**Consultation Response from Mike Hibbert,
 KC Waste Strategy(Refuse & Recycling)**

2023/93539 Land adj, Ledgard Bridge Mill, Back Station Road, Mirfield, WF14 8NZ

Outline application, including the considerations of access appearance, layout, and scale, for the erection of a six-storey building to host 76 residential apartments (C3 use) and ancillary works comprising demolition of vacant building, formation of new access, parking areas, open space and landscaping; erection of cycle and bin refuse storage structures

Responding Ref: WPN 23-065

Bin stores for new development

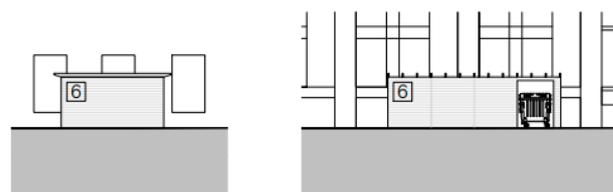
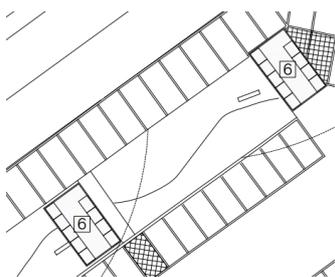
- Guidance indicates that for 76 apartments the recommended waste storage provision is approximately 13,680ltrs (76X180 ltrs) for both residual and recycling bins covering an alternate weekly collection cycle. Current collection provision for the existing block is 18 x1100ltrs wheeliebins servicing 119 apartments. Using this existing data then the proposed store containing 12x 1100ltrs wheeliebins for the new block should be adequate. Consideration will have to be given to separate bins for recycle and residual wastes plus some storage provision should be included for separate collection of food waste to ensure compliance with forthcoming Government Simpler Recycling legislation.

- If adequate storage cannot be accommodated on site, then there may need to be a review the of configuration of residual and recycling provision or the management company for the development could consider more frequent collections (e.g., weekly residual) on an additional paid for basis. KC Trade waste staff can arrange to meet on site and discuss potential solutions.

- Guidance indicates the floor space for a 1100ltrs wheelibins is 1575mmx1190mm with space to manoeuvre the bins within the store. The bin stores are screened and are approximately 11.5m and 5.8m long respectively. Using these dimensions, the wheeliebins, eight and four respectively, should just fit in the stores. Bin store surfaces should be durable and waterproof enough to withstand heavy duty cleaning such as power washing.

- The waste stores should be secure to prevent theft, unauthorised use/ fly tipping or rough sleeping. If doors to the bin store are installed or there is use of locks or a keypad to secure access, these details will be required by the collection staff.

- Waste storage should address the fire risk issues presented by large quantities of waste. See BS5906:2005, Building Regs 2010 Part H6 and CFP-A-E Guideline No 7:2022 F. The stores are 6m away from the buildings and constructed of suitable material to contain and prevent the spread of fire.
